SUBJECT: Addendum to Responses to Questions on Addendum 2 to EPRI
Performance Prediction Program Topical Report TR-103237-R2
Thrust Uncertainty Method

PROJECT NUMBER: 689

**Addendum to Responses to NRC Comments on
Addendum 2 to EPRI TR-103237-R2**

Figure 1. Histogram of Prediction Ratios (Actual and "Mirrored")

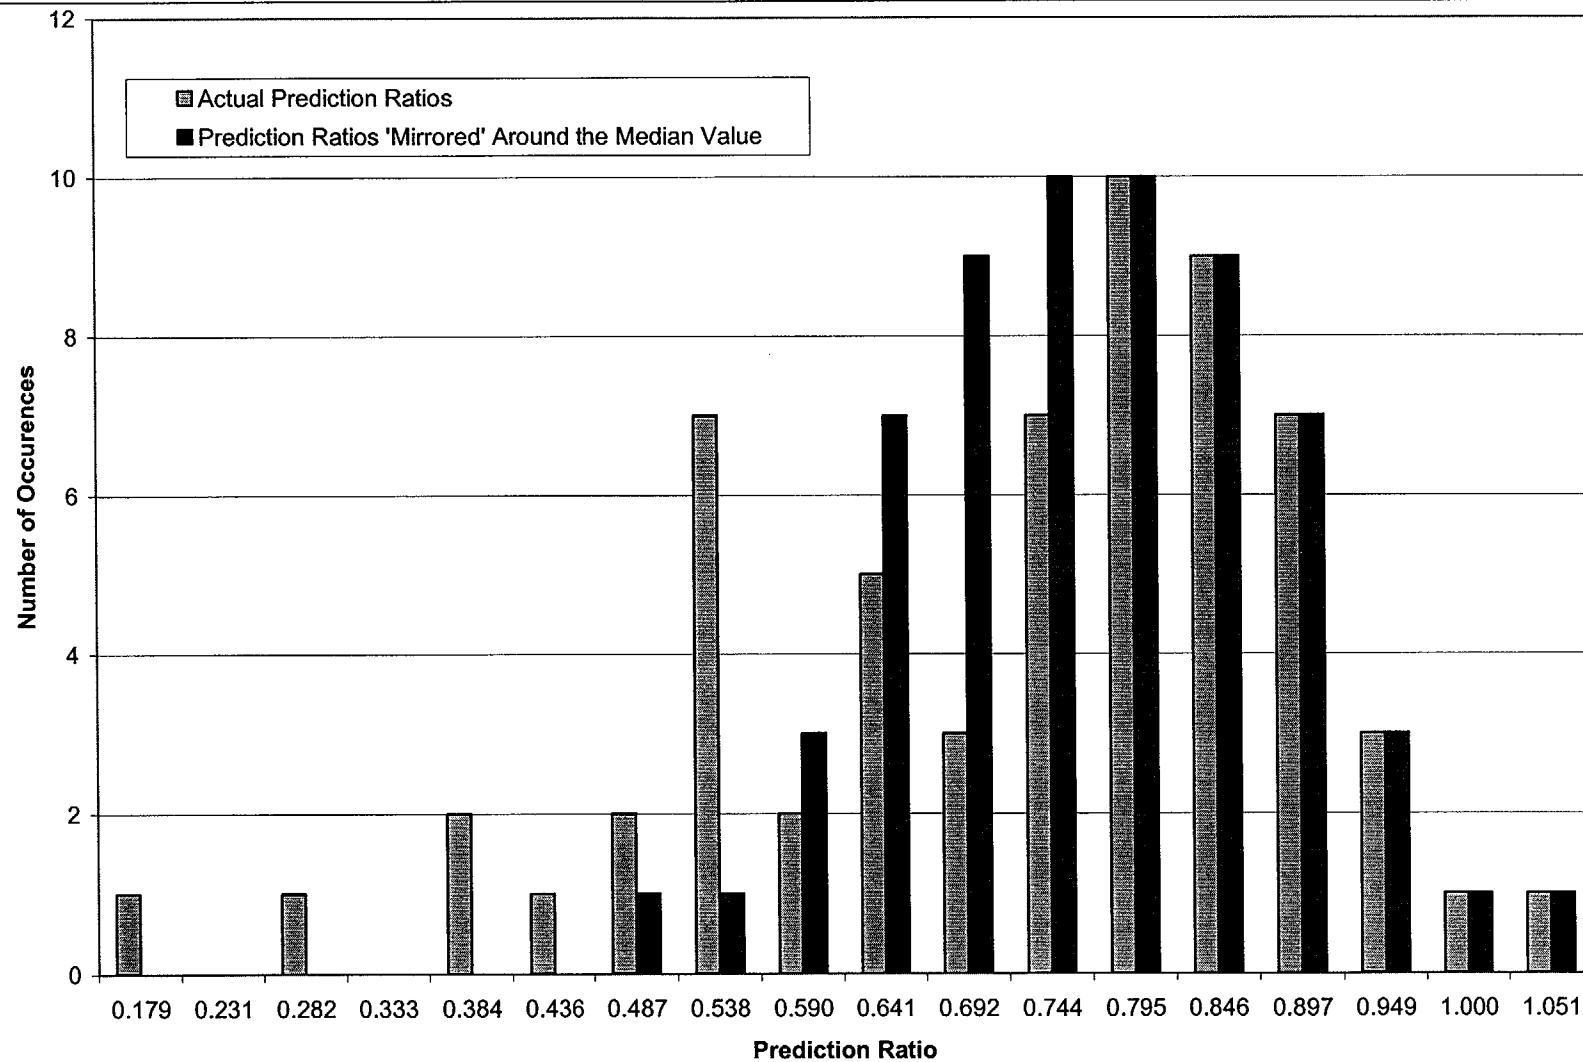
- New data points (that are less than the median value) are added to the population to create a "mirror" image of the values above the median. For each value greater than the mean (by an amount x), a new value is added to the population that is x less than the median. The data set created in this way, which has both an average and a mean equal to 0.7435, is shown in the second column of Table 1. Figure 1 shows histograms of the actual prediction ratio data and the prediction ratios "mirrored" around the median.
